SUBJECT: COMANCHE PEAK STEAM ELECTRIC STATION (CPSES)
DOCKET NOS. 50-445 AND 50-446
ADVANCE FSAR SUBMITTAL - RCS COOLDOWN TIME AFTER
RHR INITIATION

CPSSES - FINAL SAFETY ANALYSIS REPORT (FSAR)
AMENDMENT / REVISION 87
DETAILED DESCRIPTION

COMANCHE PEAK S.E.S.
FINAL SAFETY ANALYSIS REPORT
UNITS 1 AND 2
SINGLE TRAIN RHR COOLDOWN
FIGURE 5.4-9

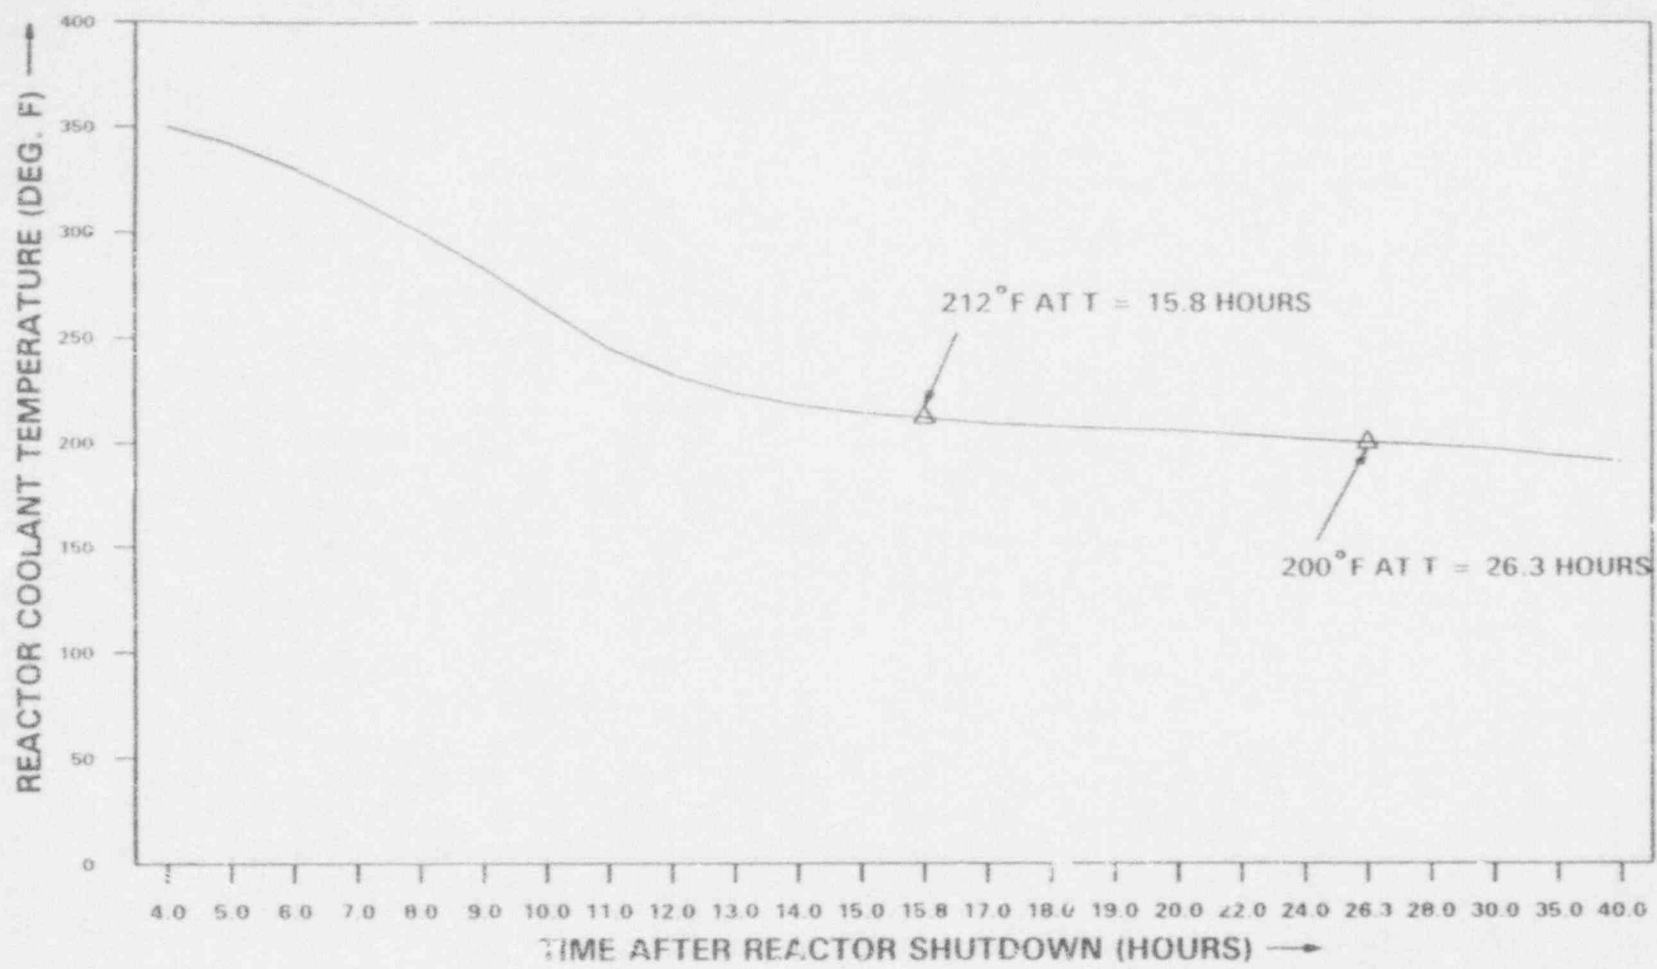
- 2 A new figure reflects the revised RHR system cooldown capabilities.
Revision :
See Justification for SA-92-811.1.
Change Request Number : SA-92-811.5
Commitment Register Number :
Related SER : 5.4.3.2 SSER :22 5.4.3.2
SER/SSER Impact : Yes
FSAR Figure 5.4-9, "Single Train RHR Cooldown," has been revised.

Assuming that only one heat exchanger and pump are in service and that the heat exchanger is supplied with component cooling water at design flow and maximum temperature, the RHRS is capable of reducing the temperature of the reactor coolant from 350°F to 200°F within 23 hours. The time required under these conditions, to reduce reactor coolant temperature from 350°F to 212°F is 12 hours.
